Pentium® Pro Processor Specification Update

Release Date: January 1999

Order Number: 242689-035

Figure 4-3. Stack Switch on a Call to a Different Privilege Level

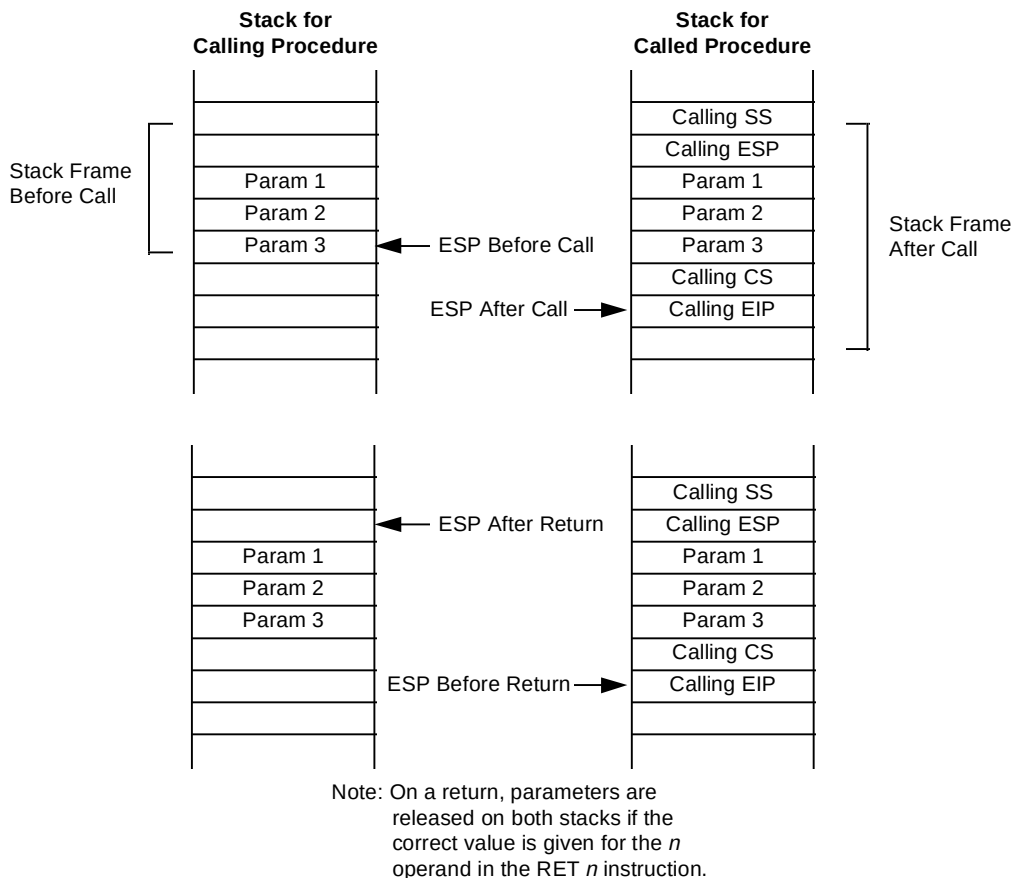
When making a call to a more privileged protection level, the processor does the following (see Figure 4-3):

4. Restores the SS and ESP registers to their values prior to the call, which causes a switch back to the stack of the calling procedure.
5. (If the RET instruction has an optional n argument.) Increments the stack pointer by the number of bytes specified with the n operand to release parameters from the stack (see explanation in step 3).

6. Resumes execution of the calling procedure.

Figure 4-4. Stack Usage on Transfers to Interrupt and Exception Handling Routines

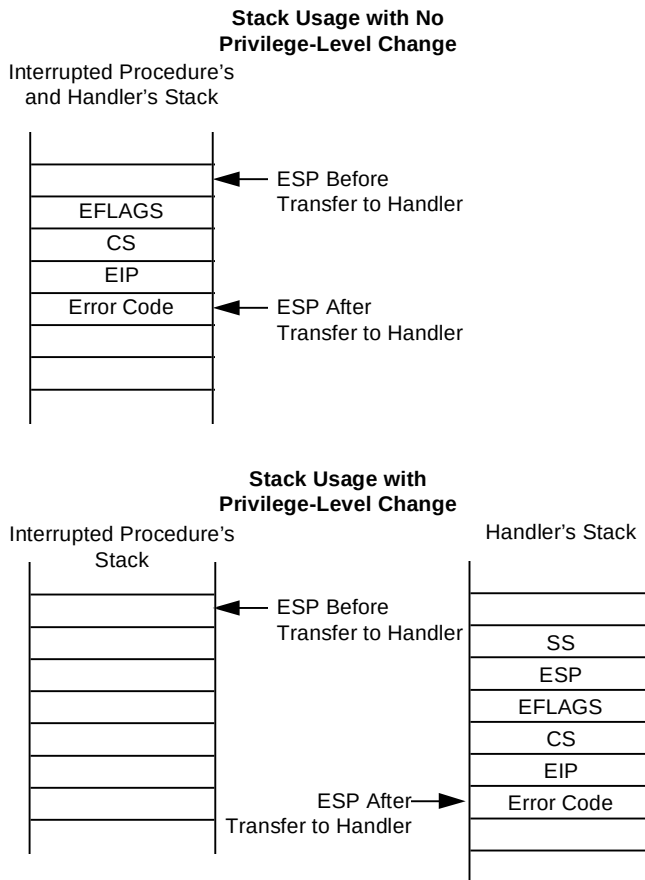
If no stack switch occurs, the processor does the following when calling an interrupt or exception handler (see Figure 44):

1. Performs a privilege check.
2. Restores the CS and EIP registers to their values prior to the interrupt or exception.
3. Restores the EFLAGS register.

4. Restores the SS and ESP registers to their values prior to the interrupt or exception, resulting in a stack switch back to the stack of the interrupted procedure.
5. Resumes execution of the interrupted procedure.
